EXECUTIVE - 7 MAY 2024

## Notice of public question (Procedure Rule 10) – Executive 7 May 2024

## **Notice of Member's question (Procedure Rule 11.2) – Executive 7 May 2024**

Figure 42. Proposals for Cycle Route 3

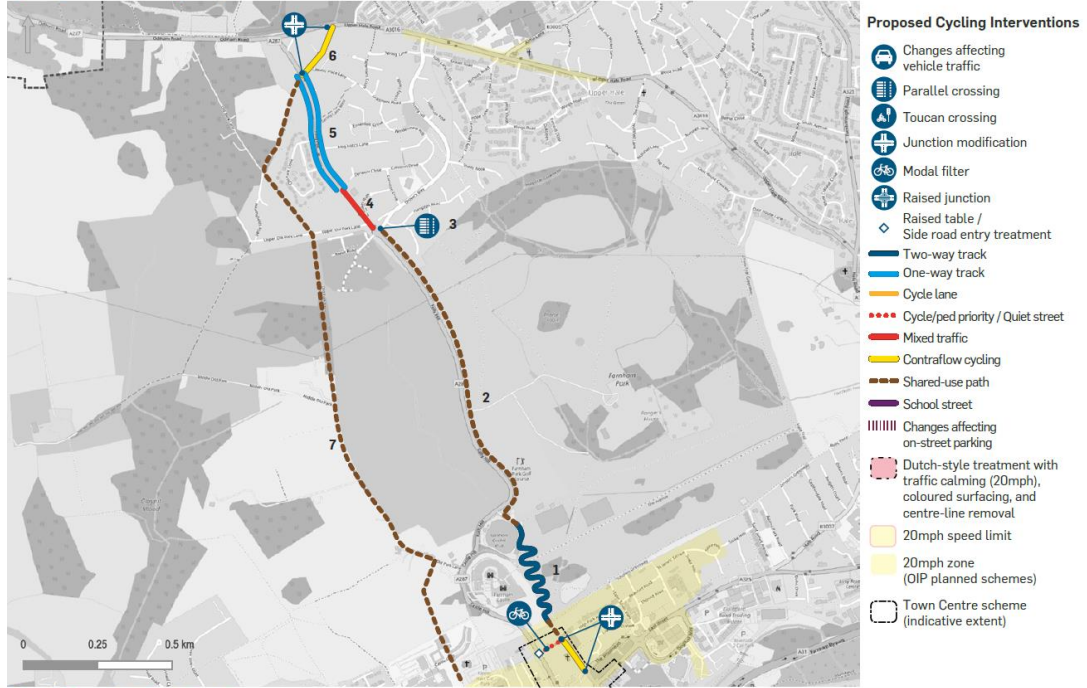
- c. In the case of the “Castle Hill Realignment”, do not address the concerns raised in the public consultation meetings in the Summer / Autumn of 2023 and will instead cause further confusion. Cycle Route 3 (see map below) was reviewed during the Summer Public engagement sessions and the route along Old Park Lane was preferred to the route along Folly Hill and adjacent to the Castle. The Old Park Lane Route was included in the priority routes. The WBC Officers have I believe argued that the Castle Hill Realignment addresses the concerns raised regarding impact on archaeology and ecology associated with that route. However, as can be seen in Figure 1 below, this is not the case, as well as archaeology there are also ecology and safety concerns.
